## **REMARKS**

Figures 1, 2, 4, 5, and 8 have been amended, and the changes shown in red ink on one set of the accompanying drawing sheets.

**KEDI 7230 US**

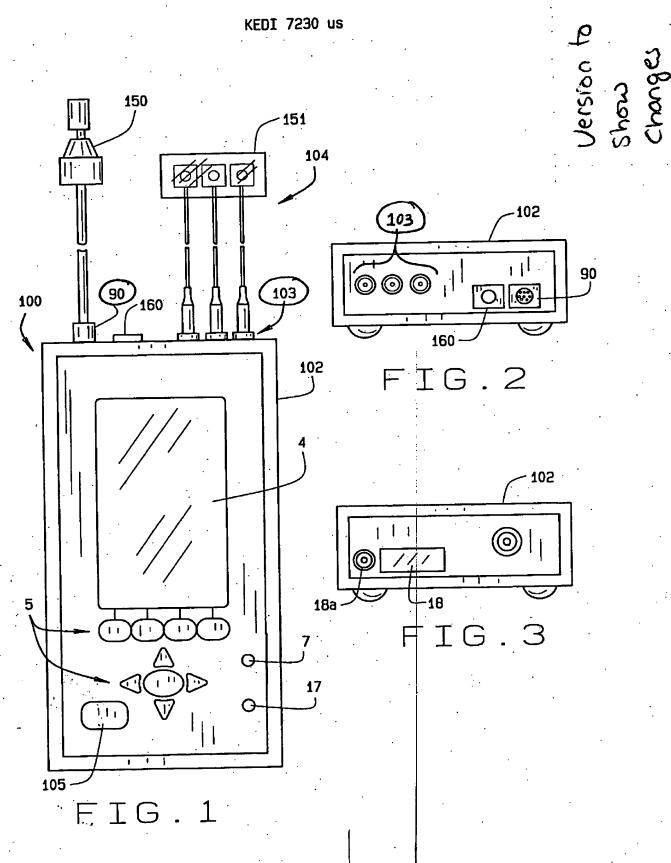
In Figure 1, reference numeral "9" has been changed to reference numeral "90" as indicated, corresponding to the changes to the Specification at Page 6, set forth in the accompanying Amendment B document. Reference numeral "103" has been added to identify the "interface 103" described in the specification at Page 6.

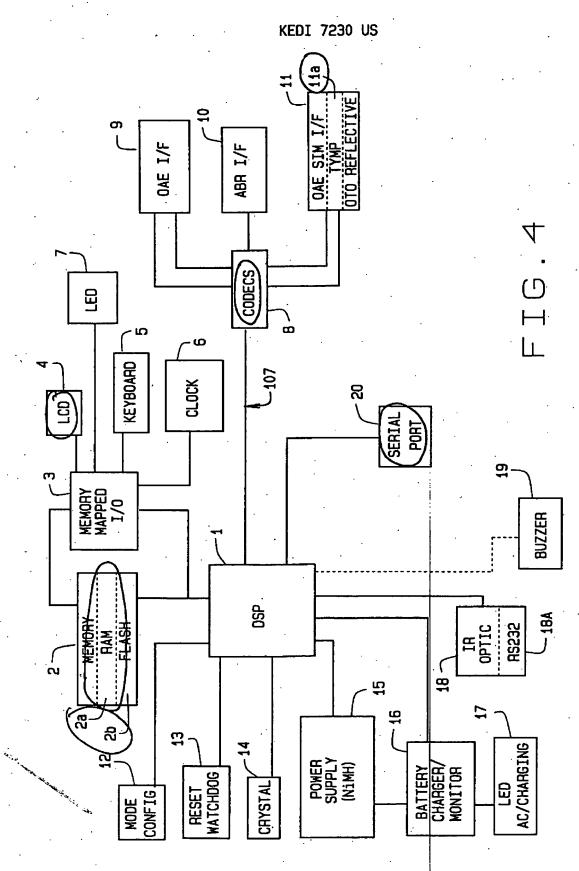
In Figure 2, reference numeral "103" has been added to identify the "interface 103" described in the specification at Page 6.

FIG.5

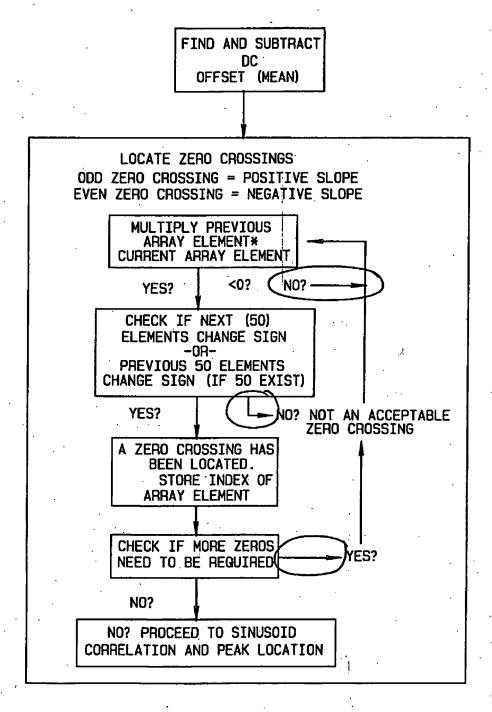
In Figure 5, three connecting arrows have been added indicating the process directions for "NO" at the first and second boxes, and the "YES" process direction at the fourth box.

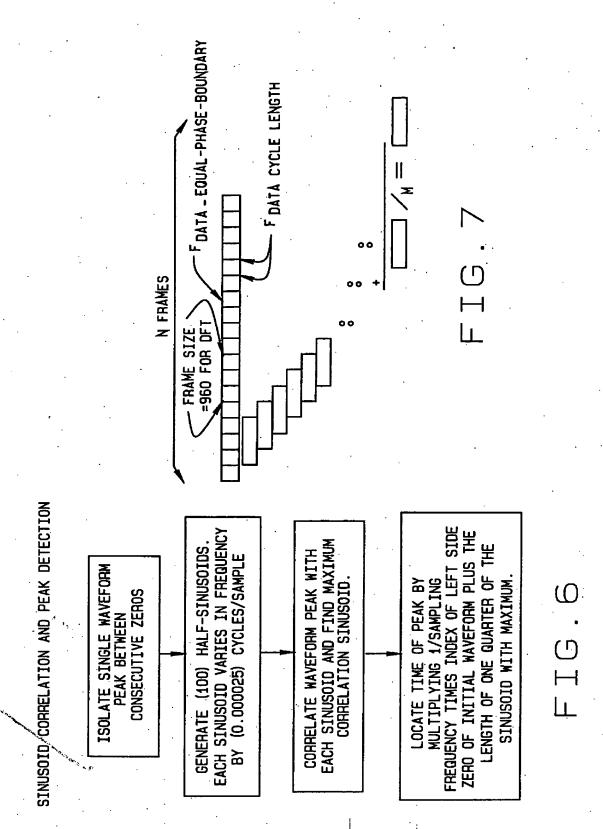
In Figure 4, reference numerals "2a" and 2b" have been added to identify the "random access memory (RAM) 2a" and the "flash memory 2b" described in the Specification at Page 7, lines 22-26. Reference numeral "11a" has been added to identify the "tympanometry interface 11a" described in the Specification at Page 9, line 32. Reference numeral "107" has been added to identify the "dedicated serial link" described in the Specification at Page 8, lines 20-22. The label "LLD" associated with reference numeral "4" in Figure 4 has been corrected to read "LCD". Similarly, the label "JTAG/ONCE" associated reference numeral "20" has been corrected to read "SERIAL PORT", and the label "CODE CS" associated with reference numeral "8" has been corrected to read "CODECS".

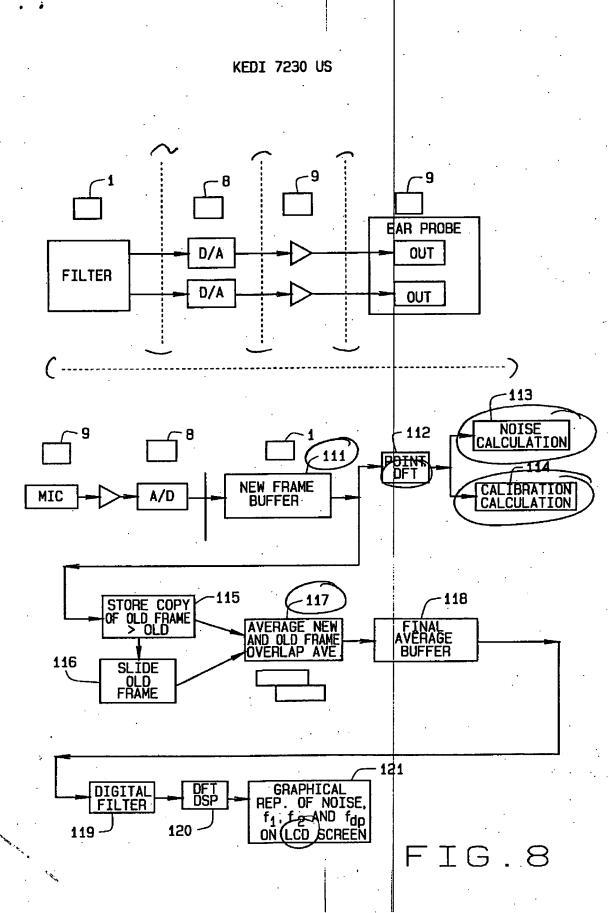
In Figure 8, dashed lines have been added to better distinguish which parts of the operational sequence are taking place within discrete components of the auditory testing device of the present invention. Reference numeral "110" has been corrected to reference numeral "111". Similarly, the second occurrence of reference numeral "114" appearing at the box labeled "Average New and Old Frame Overlap Ave." has been corrected to reference numeral "117". Abbreviated descriptions in boxes 113 and 114 have been expanded. The term "OFF" appearing in box 112 has been corrected to "LCD".
